P.O.A.D.P.  
SANTIKOS 281 / 1604

## POADP APPLICATION

Re: Santikos 281 - 1604

RE: Santikos 281/1604 P.O.A.D.P.

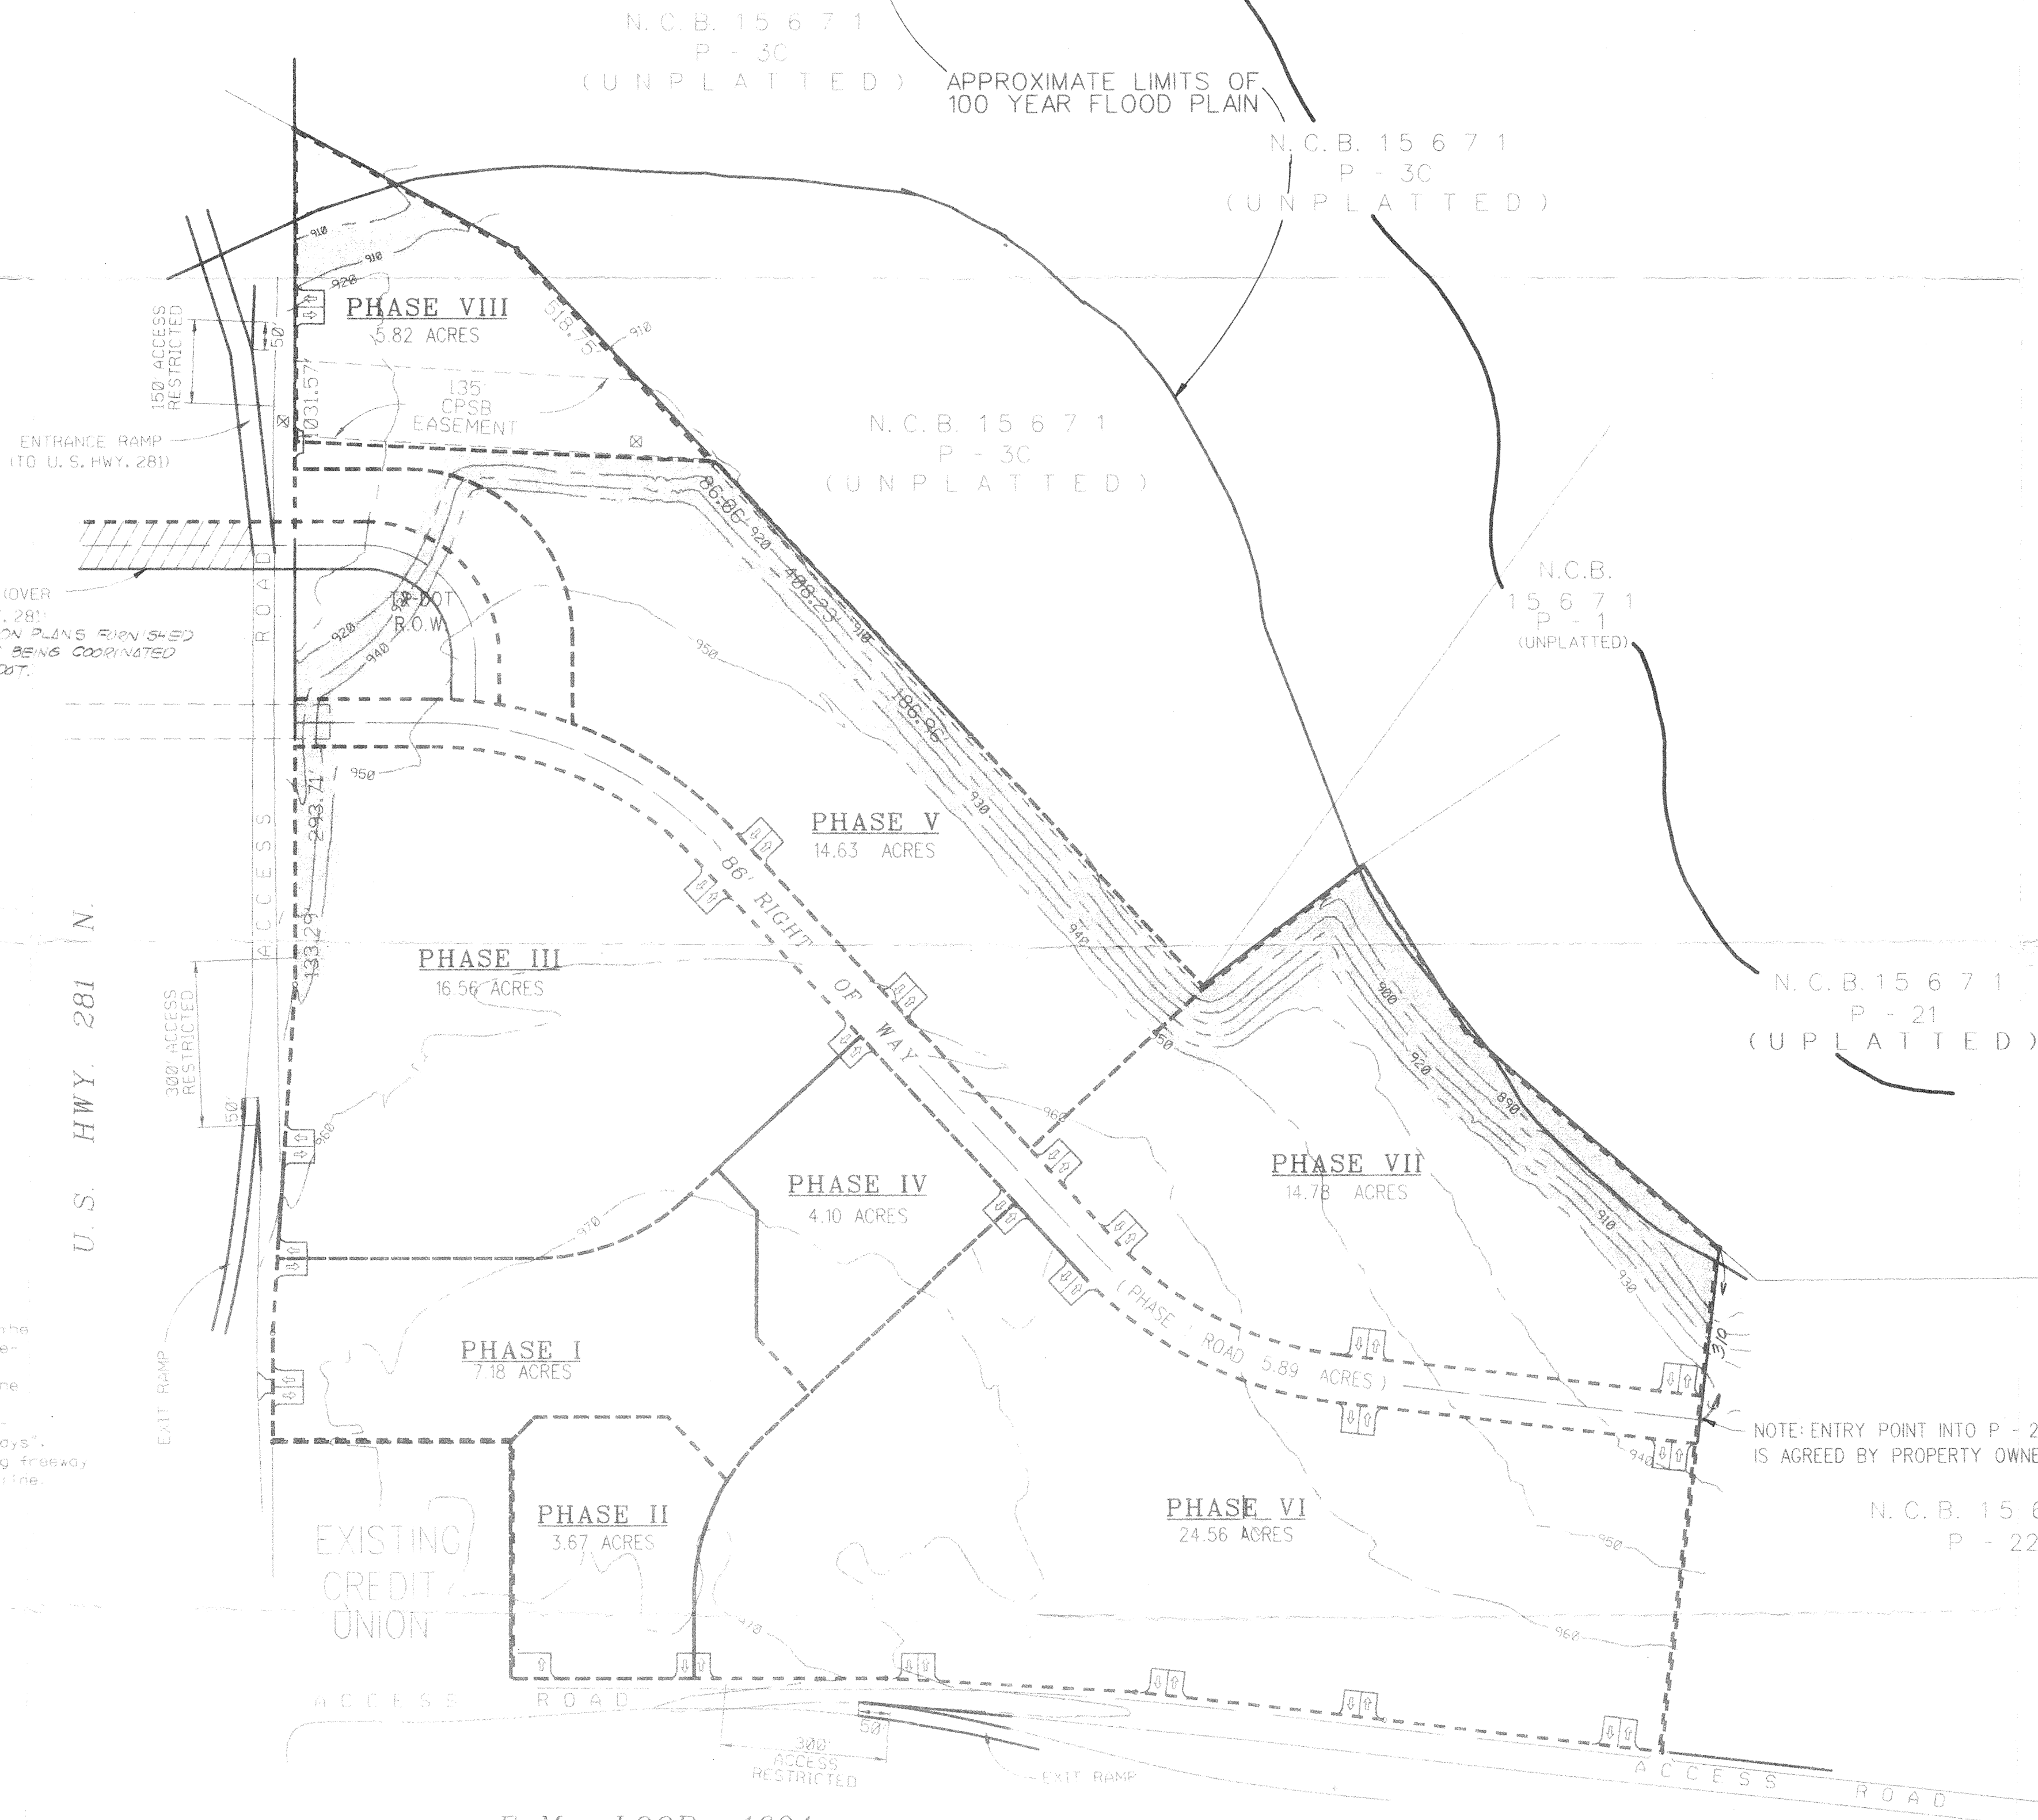
- Based on the topography, a Flood Plain Study and drainage review will probably be required during the platting process.
- In consideration of public safety and convenience, excessive grades by reason of topography should be avoided in street layouts and arrangements.

- Access and R.O.W. issues along State facilities will need to be resolved with the Texas Department of Transportation (TXDOT). For information about these requirements you can contact TXDOT at 615-5814.

- The east-west alignment will need to be coordinated with the adjacent property owners.
- This development will need to comply with tree preservation ordinance #85262. For information about these requirements you can contact Building Inspections at 207-7102.

As you are aware the Texas Department of Transportation is planning to construct an interchange between US 281 and the major thoroughfare known as Centre Park. Your layout indicates an access point at this interchange that is within TxDOT right of way. This access point is not acceptable and will not be permitted. Please refer to the attached layout.

The roadway schematic prepared by TxDOT, established control of access along the right of way at this interchange. This control of access issue was explained and understood in our meeting of January 1998, between TxDOT, Mr. Andrew Johnston (Santikos Investments), and your firm. As this development is in the preliminary stage, it is of the utmost importance that this access point be removed from the POADP. This will avoid future misconceptions of permissible access when this property is marketed and developed.

The locations of the access points along US 281 and Loop 1604 are acceptable as shown and will be the maximum permitted.

**NO Access  
Permitted  
Remove From  
POADP**

- The interconnect w/ the existing bridge appears to be incorrectly drawn. Coordinate paper layout w/ TXDOT & resubmit this
